LITTON MARINE SYSTEMS BridgeMaster E Service Bulletin Addendum No. 1 to Bulletin No. 3

10CM / S-BAND ANTENNA MOTOR

DUAL VOLTAGE MOTOR CONFIGURATION

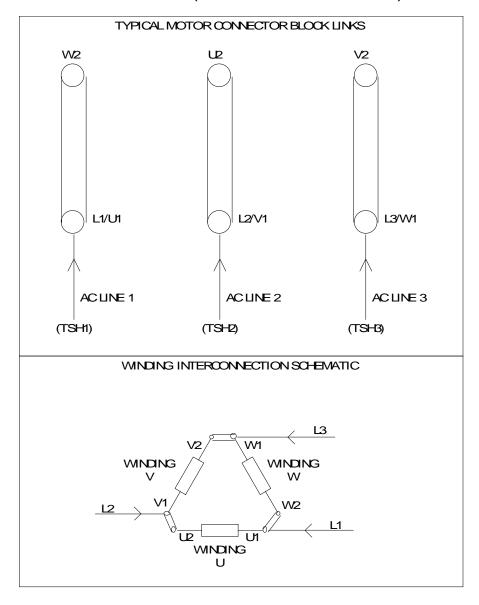
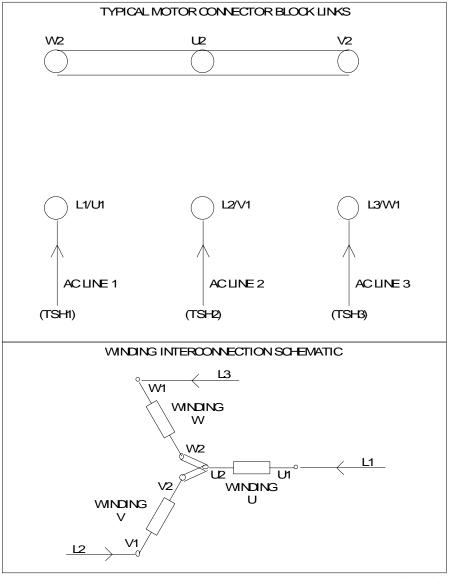
There have been several instances of incorrect configuration of the wiring within the motor at the time of commissioning. Inside the motor cover there is a sketch detailing the method of star or triangle (Y or delta arrangement).

All motors supplied are wired for maximum voltage i.e. 380/340 volts (star or Y) and vessels with a lower voltage of 220/140 volts (delta or triangle) must have the wiring rearranged.

The attached diagram should help in correctly terminating the wires to ensure the right torque of the antenna is achieved. Should you have a case of an antenna/azimuth occasionally stopping/slipping, it is quite likely that the higher voltage has been left selected at the motor from the time of installation.

220/240V (DELTA OR TRIANGLE)

380/440V (STAR OR Y)
